**ADDENDUM NO. 2  
TO CONTRACT DOCUMENT PLANS SPECIFICATIONS**

**PROJECT: MWA METRO PARK EAST LANDFILL  
P-65 CELL F LINER CONSTRUCTION**  
**TO: PROSPECTIVE BIDDERS AND OTHER INTERESTED PARTIES**

METRO PARK EAST  
MWA PROJECT P-65  
PHASE II CELL F LINER CONSTRUCTION

SOUTHWEST STOCKPILE  
LAYOUT PLAN

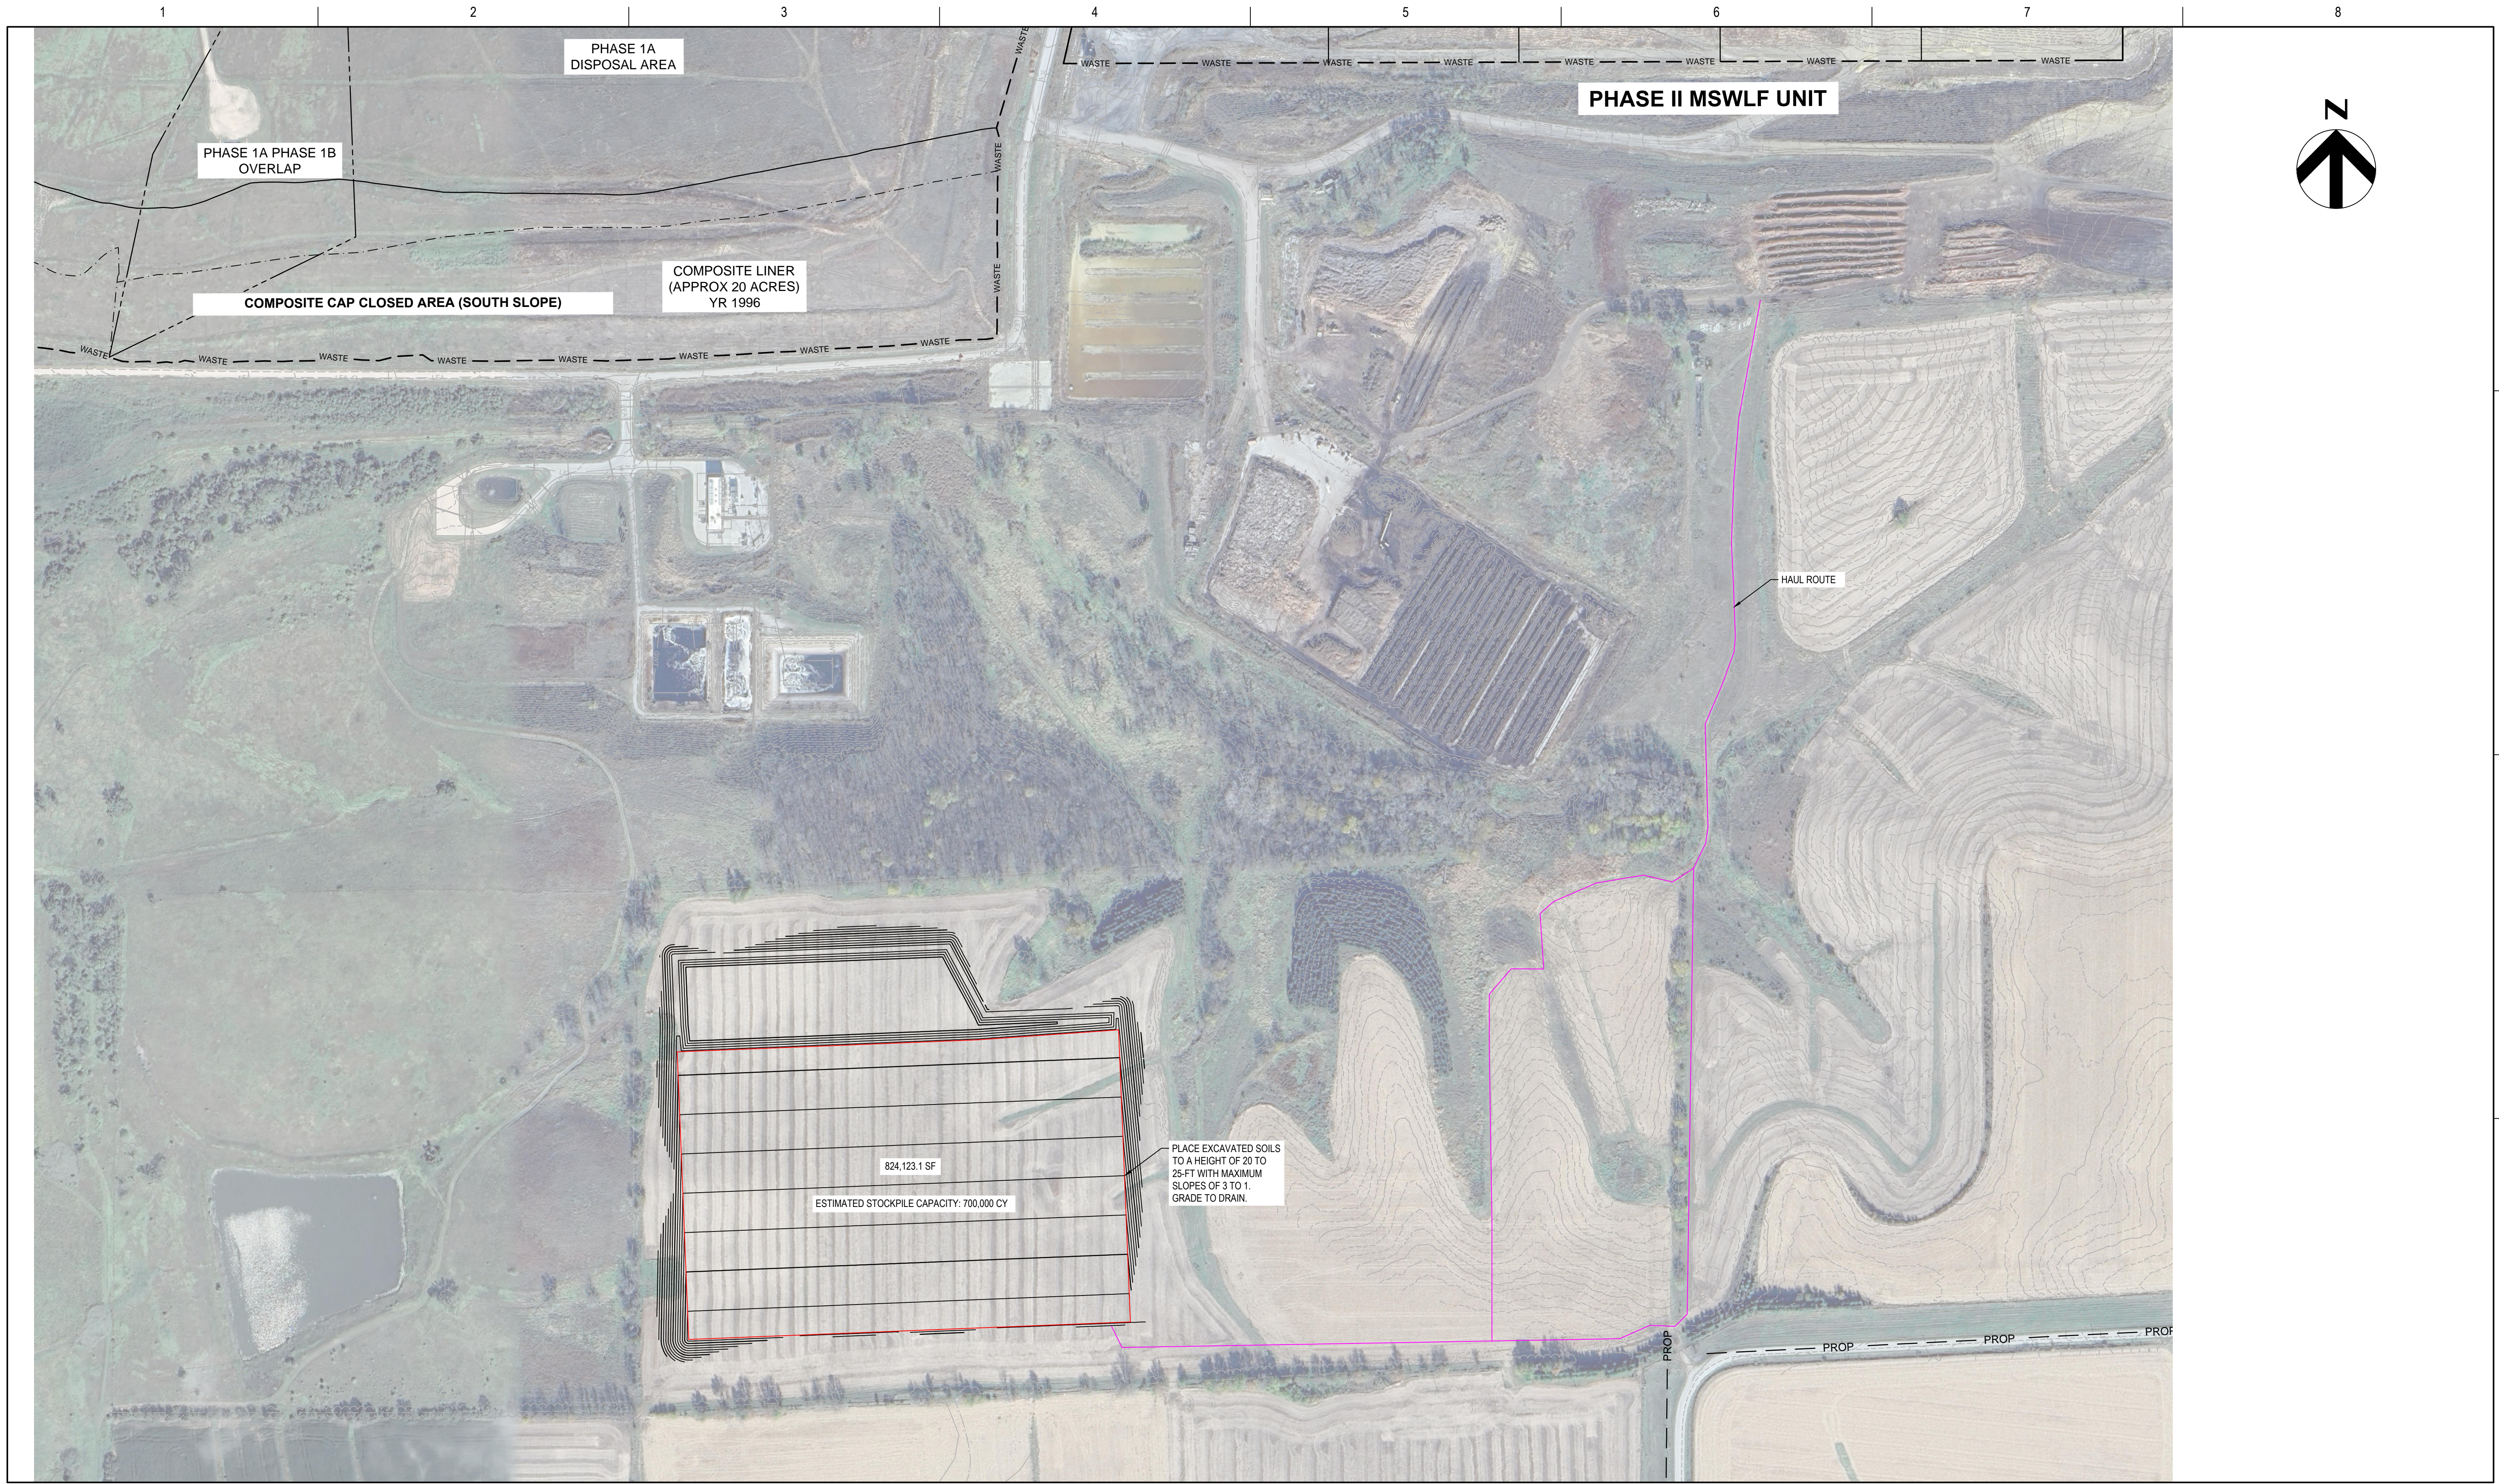
*Question 23: Is there a design that the stockpiles are to be built to? The Alternate area (SW of the compost area) will require a large footprint for that amount of yardage, a design would aid in the exact area that needs to be stripped and protected with various erosion control measures.*

*Question 42: Are there final design grades that need to be adhered to when placing the soils in either the Northeast or Southwest Stockpiles?*

*Question 43: Can you confirm that the entirety of the excess soils from the alternate excavation adder are to be placed in the Southwest Stockpile?*

Answer 23: Please see attached figures for the stockpile areas.

Answer 42: Yes, see attached figures.

Answer 43: Soils from the alternate excavation will be placed in the southwest or south berm stockpile area. At Owner's approval, soil volume may be moved from Bid Items A-118 or A-122 to Bid Item 106 (southwest or south berm stockpile to northeast stockpile). Maximum stockpile capacities are shown on attached figures.
